## COUNCIL ASSESSMENT REPORT

<b>Panel Reference</b>	PPSSSH-28
<b>DA Number</b>	DA2020/0352
<b>LGA</b>	Georges River Council
<b>Proposed Development</b>	Demolition works, remediation and construction of a mixed use development comprising four (4) buildings being from three (3) to twenty (20) storey's in elevation containing commercial floor space, a 145 room hotel and 254 apartments above four (4) levels of basement containing 524 car spaces, landscaping, site works and stratum subdivision.
<b>Street Address</b>	61-75 Forest Road and 126 Durham Street, Hurstville Lot 1 DP 225302 Lot 100 and Lot 101 DP 776275 Lot 10 DP 621395 Lots 1, 2,3 and 4 DP 12517
<b>Applicant/Owner</b>	Applicant- Aaron Sutherland Owner – Prime Hurstville Pty Ltd
<b>Date of DA lodgement</b>	10 September 2020
<b>Total number of Submissions Number of Unique Objections</b>	Three (3) submissions received.
<b>Recommendation</b>	Approval subject to conditions
<b>Regional Development Criteria (Schedule 7 of the SEPP (State and Regional Development) 2011</b>	Regional Development is defined in Schedule 7 of State Environmental Planning Policy (State and Regional Development) 2011.  Development with a capital investment

Figure 10: Plan showing bottle neck at north western corner.

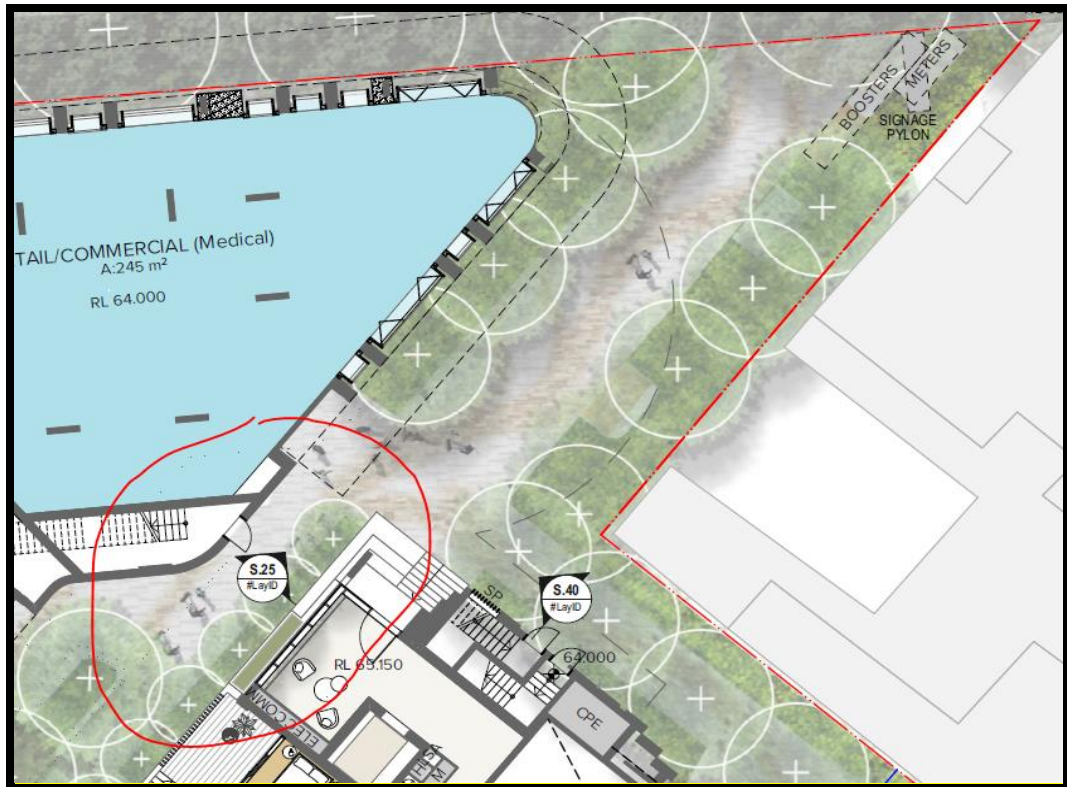
Significant concern is raised regarding the narrow width of this pedestrian through-site link. The proposed location of the main retail car parking entry on Forest Road would result in Park Lane being treated as the primary pedestrian link between Forest Road and Durham Street. This is an existing key connection for school children from nearby schools to the north of the Precinct (Hurstville Public School, Georges River College, Bethany's College and Sydney Technical High School) accessing Kempt Field and Allawah Railway Station beyond. Accordingly, visibility and amenity must be improved.

The proposal currently creates a 'bottleneck' at the north-western corner of Building A. The 9m wide connection is abruptly reduced to 3m at this point (see below):

- The lobby at the north-western corner has been redesigned to provide for a wider through site link.
  - Level 1 and 2 has been updated to remove balconies to bedrooms and increase screening to address privacy between Building A and Building B.

Figure 11: Plan showing area of building that could be reduced (outlined in red)

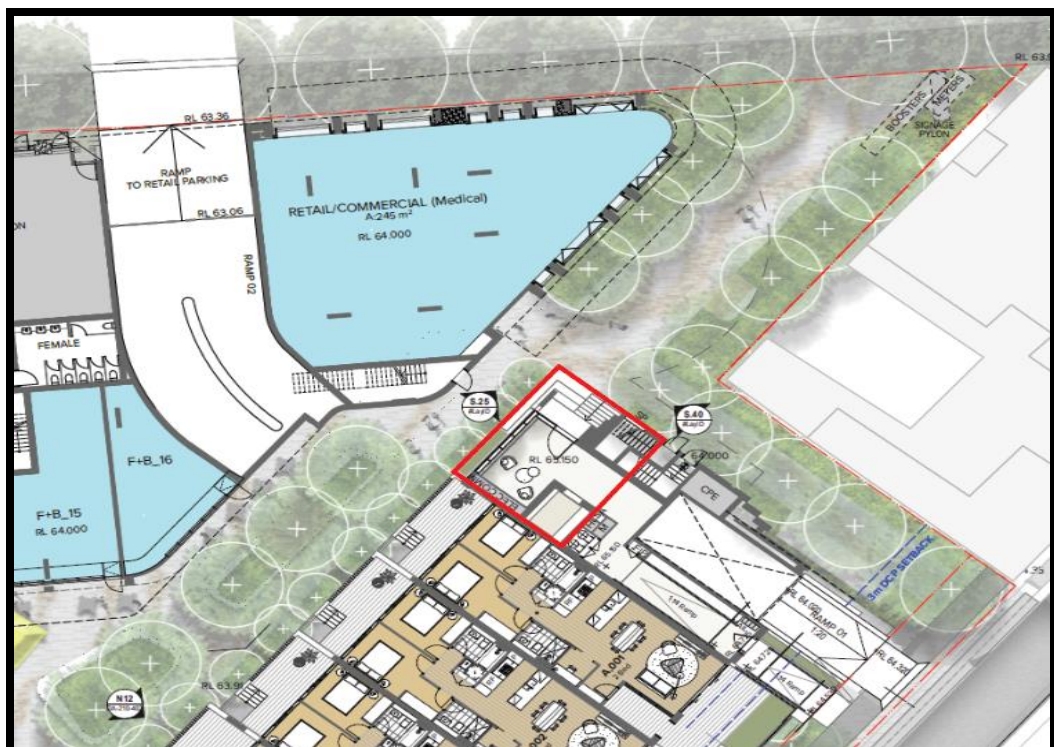
The proposal must be amended to ensure a minimum 6m width for this critical through-site link. This may be achieved by reducing the footprint of Building A at this corner (refer red outline in red below):
